October 4, 2002

Site Inspection, Robert Clark, Emeryide Mine, S/015/053, Emery County, Utah

Photographs S/015/053 Emeryide Mine

Photo 5. Mine waste that should be cleaned up. Note the plastic garbage bags near the center of the photo.

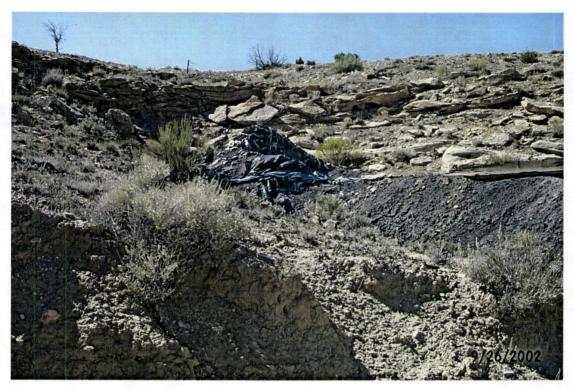
As one travels north from the portals toward the middle bench, there are some hoses and brattice that need to be cleaned up (Photo 4). Toward the top, there is a pile of what appears to be mine waste. It looks like this was in plastic bags and dumped here (Photo 5).

The operator should clean up the hoses, brattice cloth, and mine waste and the car battery if this is the operator's responsibility. Ideally, the barrels would be stored in a rubber lined concrete facility, but for this operation, it would be acceptable to have a lined earthen pit.
